**RE: Lot 41, Block 6 Volcano Cliffs Unit 18  
6639 Sueto Rd NW  
Grading and Drainage Plan  
Engineer's Stamp Date 4-20-16 (D10D003M41)**

**RE: SAD 228, Lot 41B Block 6  
6639 Sujeto Rd NW  
Grading and Drainage Plan  
Engineers Stamp Date 3/6/15 (D10D00M41B)**

**GRADING AND DRAINAGE PLAN**  
**LOT 41B, BLOCK 6, UNIT 18, VCS**  
**ADDRESS: 6639 Suero Rd NW**

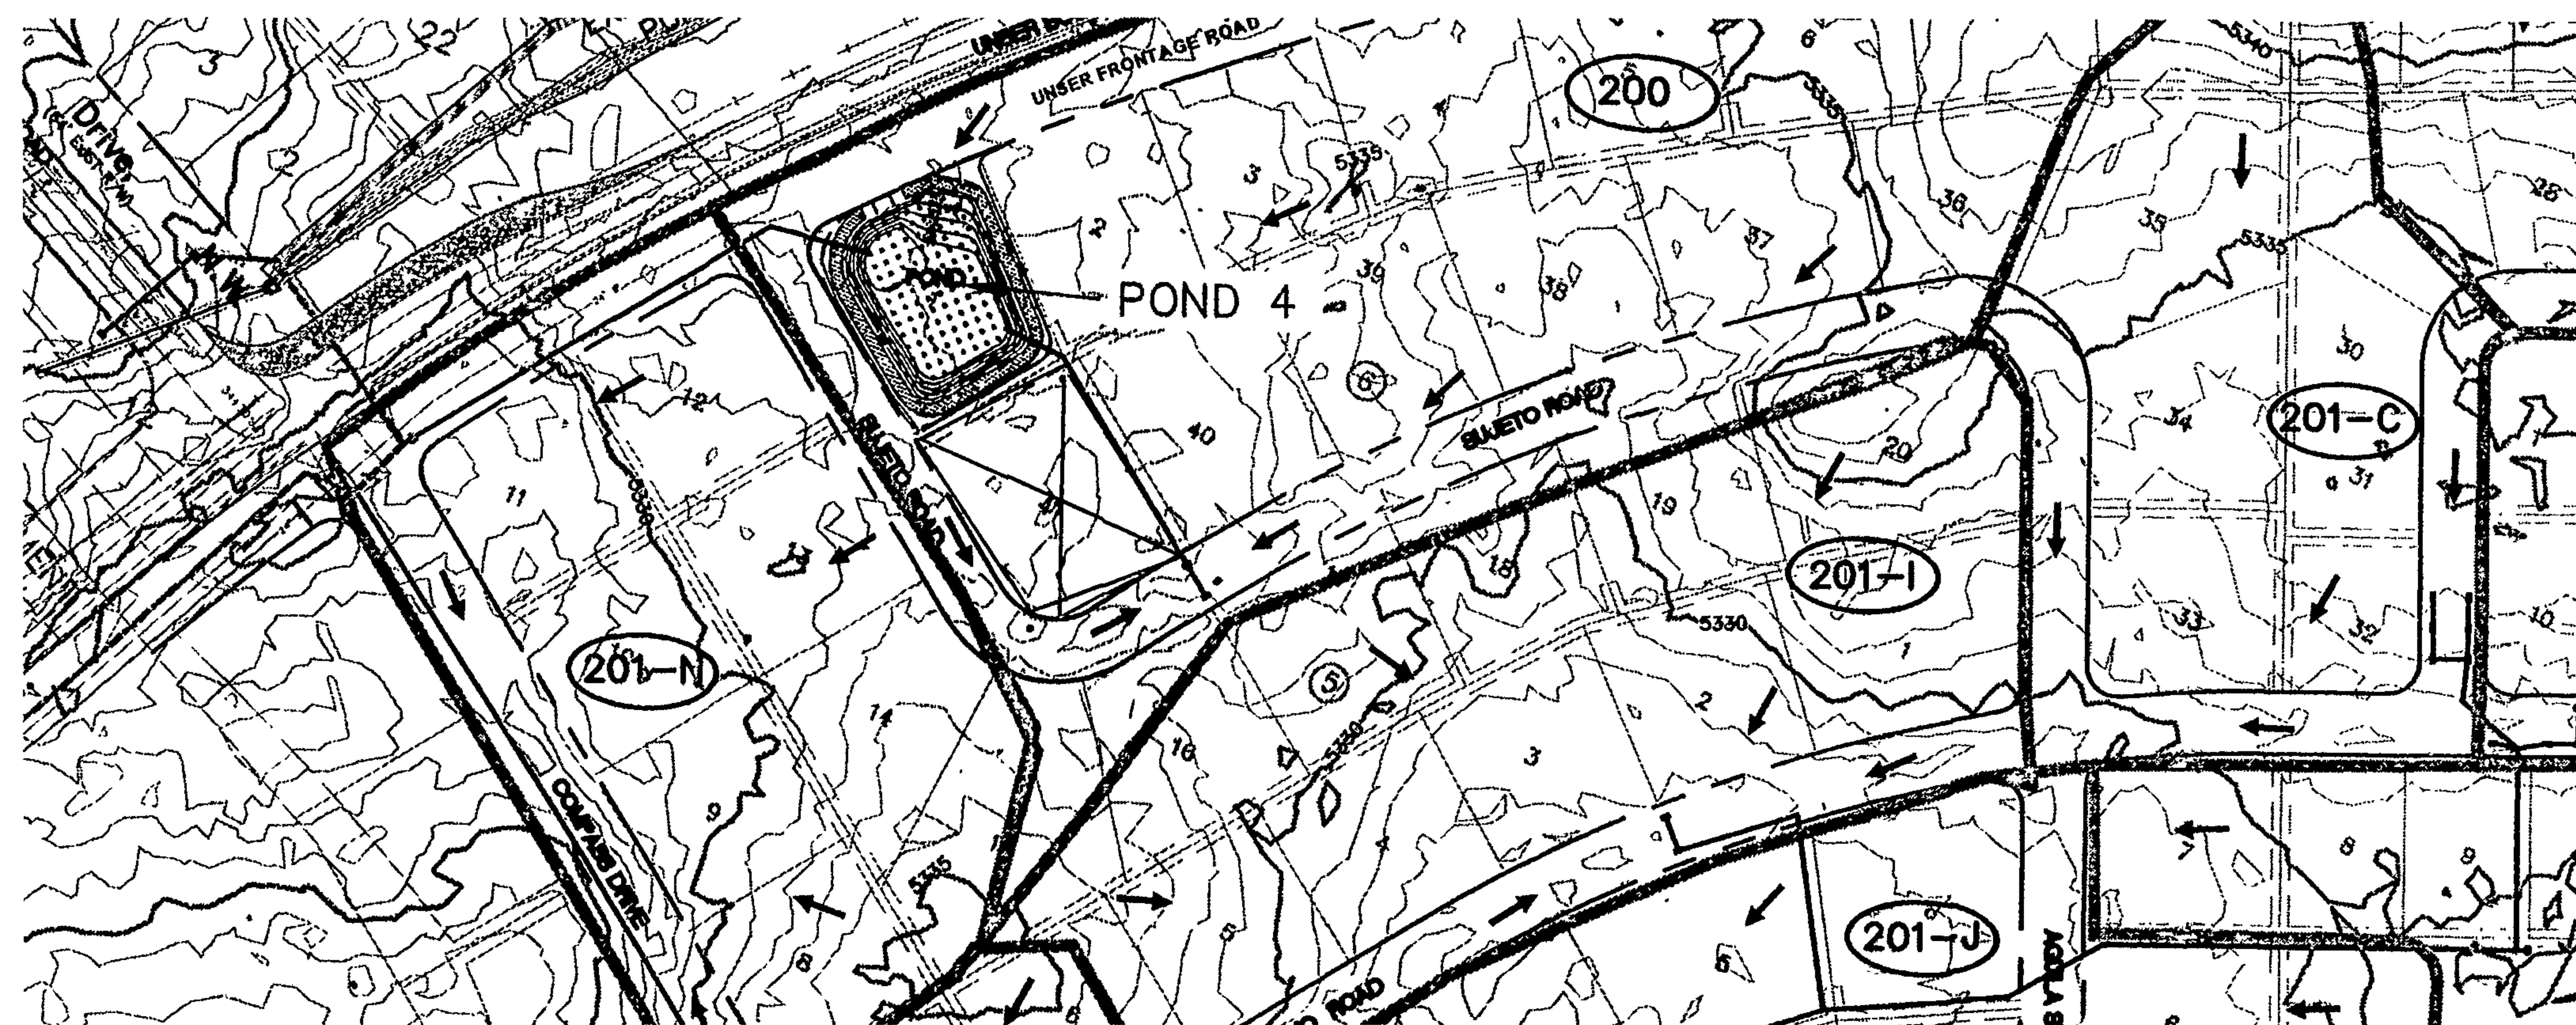
Please attach a copy of this approved plan to the construction sets in the permitting process prior to sign-off by Hydrology. A separate permit for the wall is required. Attach this approved plan to the wall permit set. Place all turn blocks 3" above grade for sediment control and landscaping.
